Applicant : Charles M. Olds et al.  
For : AUTOMATIC CHANGEOVER REGULATOR  
Page : 4

In the Drawings:

FIG. 4

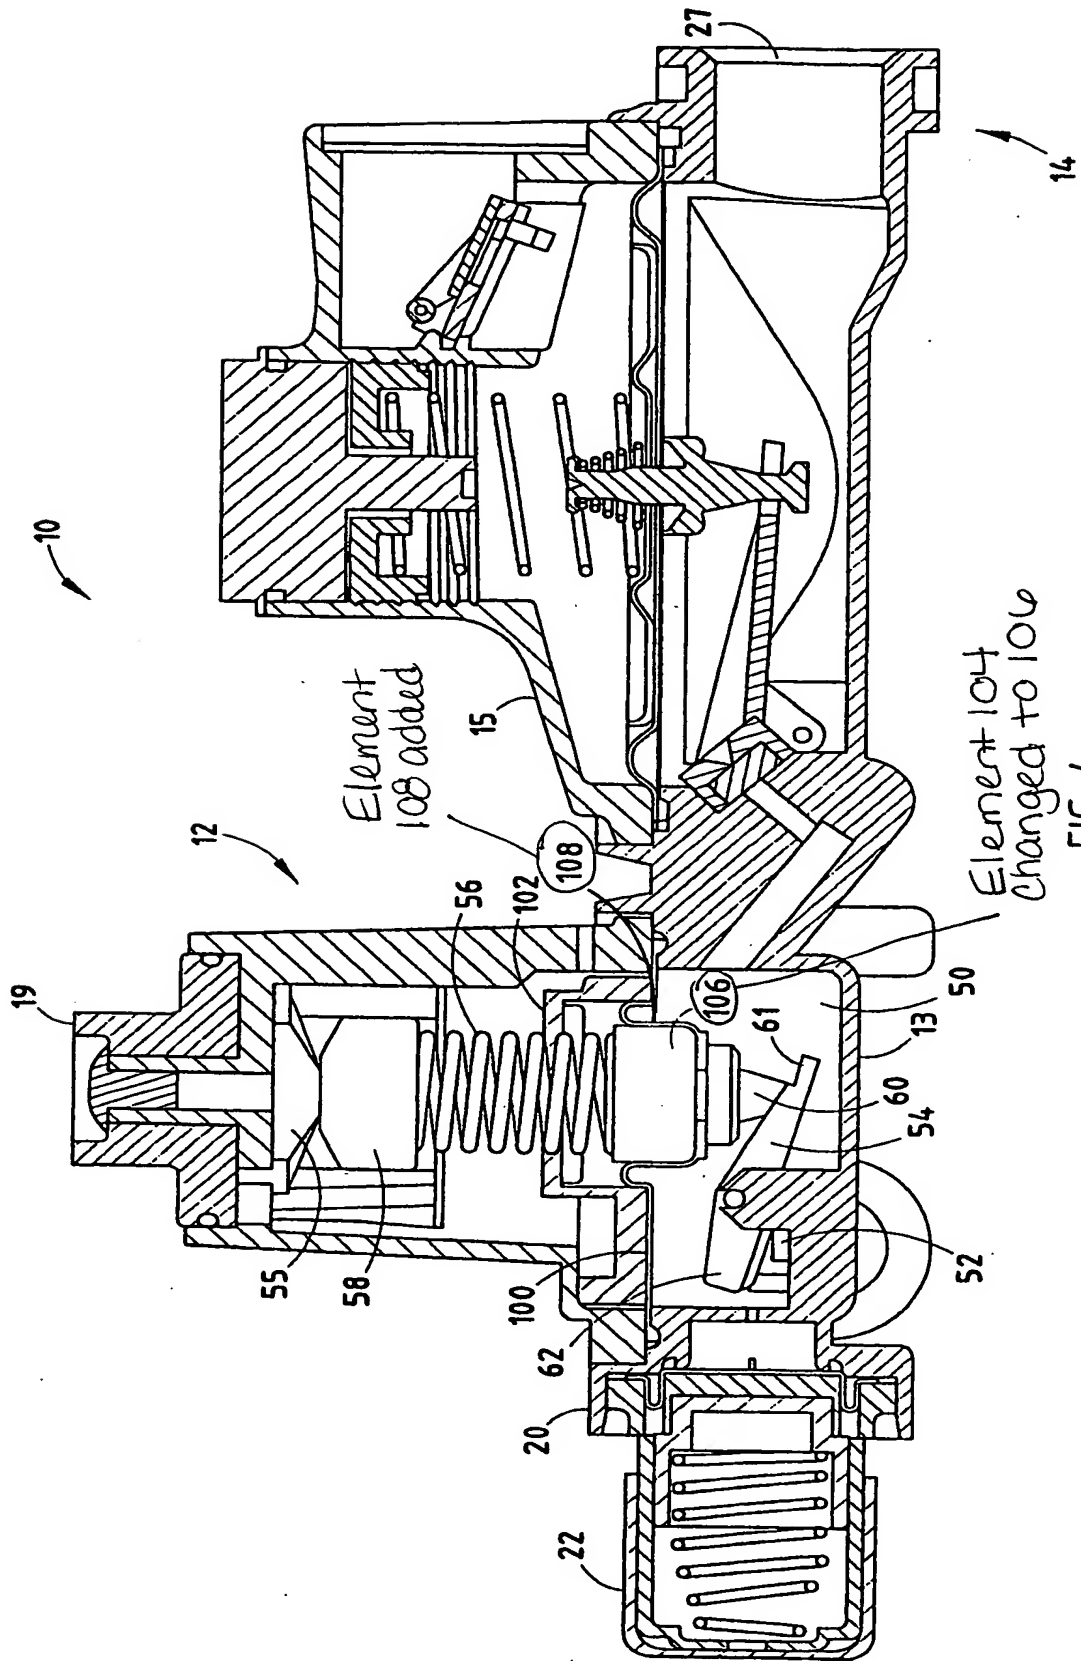
The attached sheets of drawings include changes to Figs. 4, 18 and 20. These sheets, which include Figs. 4 and 16-21, replace the original sheets including Figs. 4 and 16-21. In Fig. 4, element 104 has been changed to element 106 and element 108 has been added. In Fig. 18, element 108 has been added. In Fig. 20, element 108 has been added.
